KANSAS GAS AND ELECTRIC COMPANY

KMLNRC 84-124
Re: Docket No. STN 50-482
Ref: KMLNRC 84-118 dated 7/20/84 from GLKoester,
KG&E, to HRDenton, NRC
Subj: Technical Specifications

WOLF CREEK GENERATING STATION
UNIT NO. 1

Figure 5.1-4
Boundary for Liquid Effluents

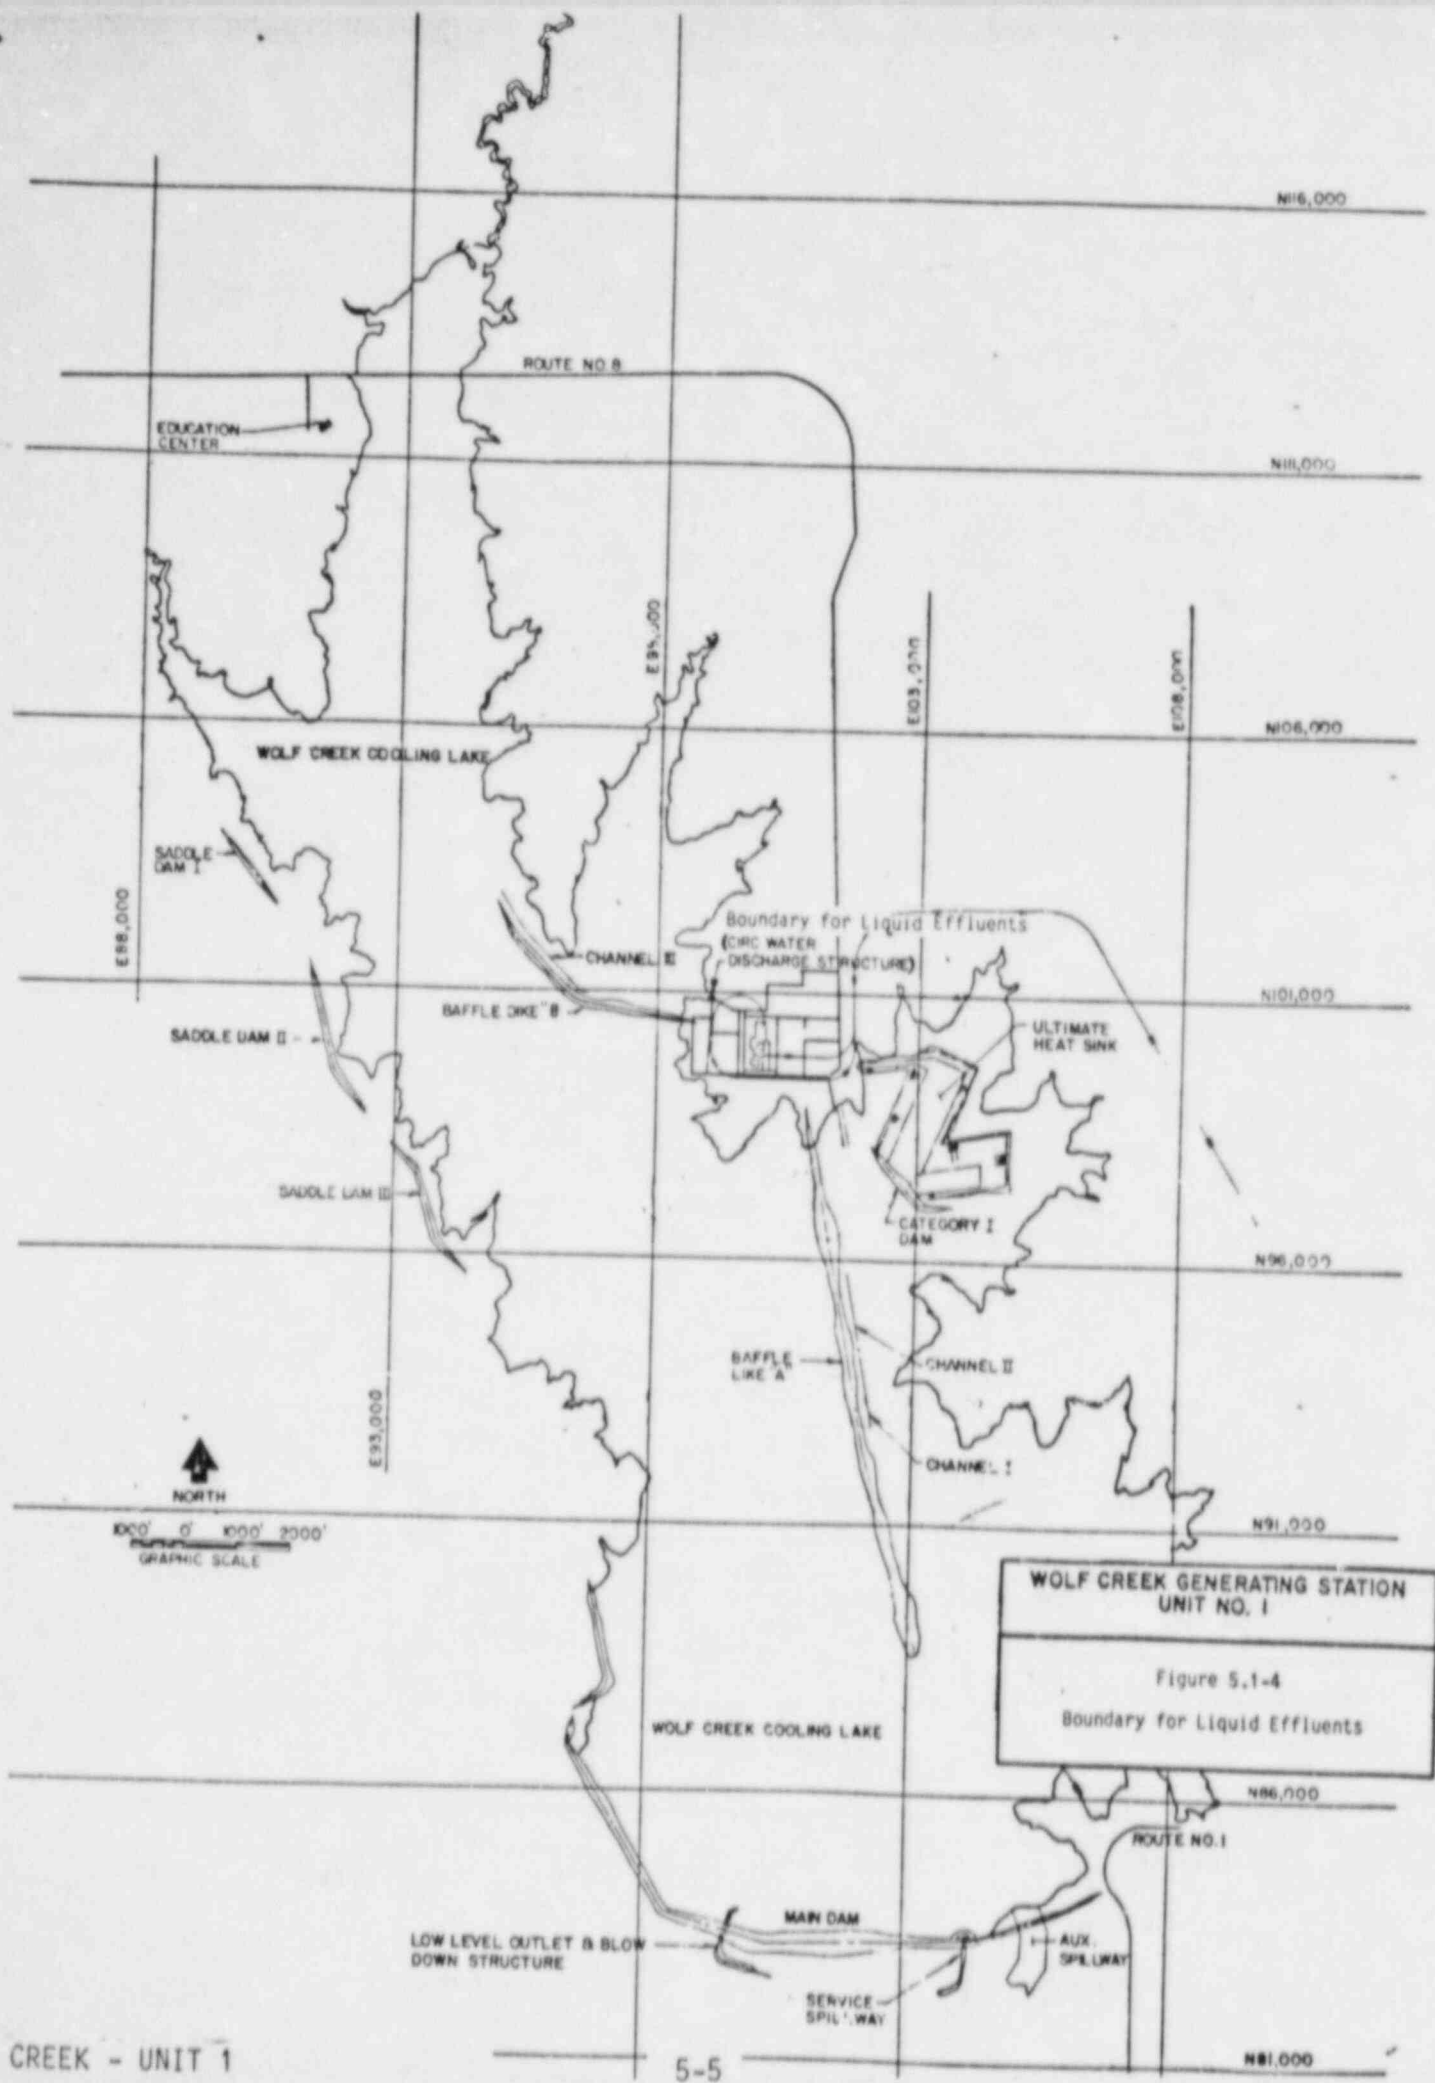
The Referenced letter transmitted the Wolf Creek Technical Specifications "marked up" to indicate changes. Figure 5.1-4, which was transmitted in the Referenced letter, does not correctly reflect the boundary for liquid effluents at Wolf Creek.

Transmitted herewith is a revised Figure 5.1-4 which correctly reflects the boundary for liquid effluents at Wolf Creek. This figure should supersede the previously submitted figure in its entirety.
